STATE OF TENNESSEE DEPARTMENT OF ENVIRONMENT AND CONSERVATION

Supplemental Inspection Information

FACILITY NAME: Yellow Creek Stone Quarry

NPDES PERMIT NUMBER: TN0070661

Photo 1: Spring fed pond below the Yellow Creek Stone Quarry. Pond appeared quite turbid for not receiving any significant rain for the past 6 days.

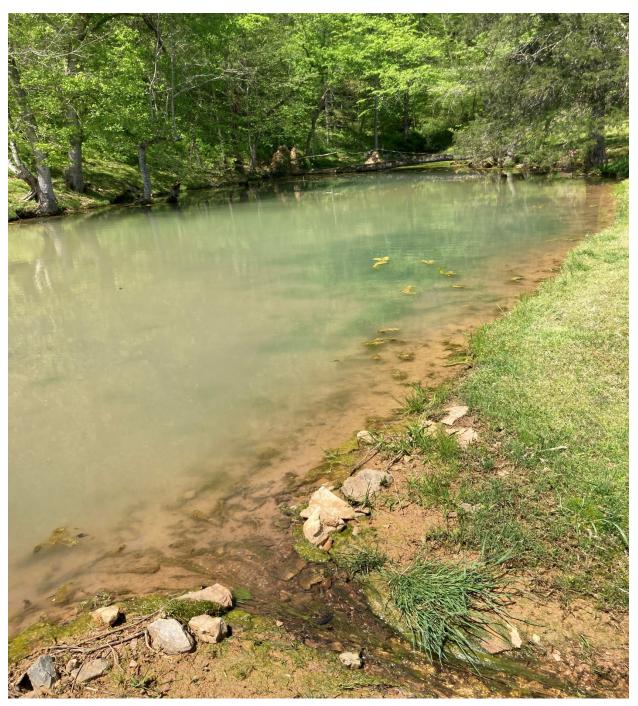
The spring fed pond below the quarry appeared to be turbid (photo 1); however, the spring water entering the pond was clear (photo 2). A potential conduit from the quarrying operation to the pond was identified (photo 3). It is recommended that the facility direct stormwater drainage away from this area and install BMPs, such as silt fencing and straw wattles, around this area to prevent sediment laden water from entering this potential conduit. It was also recommended that the facility stabilize the cleared land in this area with seed and straw or rock to prevent stormwater from accumulating large sediment loads. Additionally, allowing more littoral zone aquatic vegetation to grow along the pond shoreline may help trap and process sediment that enters the pond.

Photo 8: Large amounts of unstabilized soil at the upper portion of the driveway.

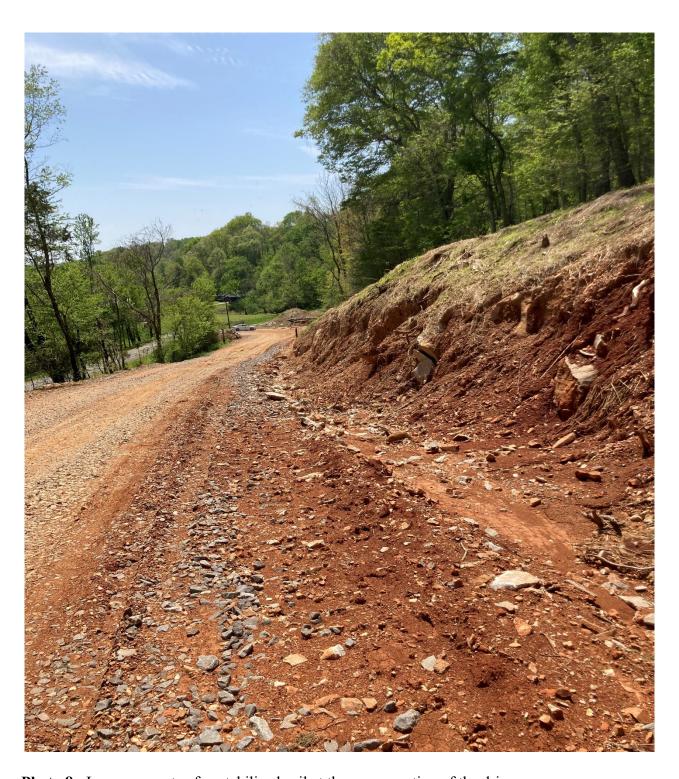
The facility appears to have installed an adequate tracking pad (photo 4) and BMPs are in place below the quarry entrance to manage stormwater runoff (photos 5-7). However, large areas of unstabilized soil were observed along the western and northern portions of the driveway that needs to be stabilized (photos 8-10). Additional BMPs such as check dams and sumps need to be installed along the driveway and roadway ditches, and unstabilized soil should be seeded and strawed.
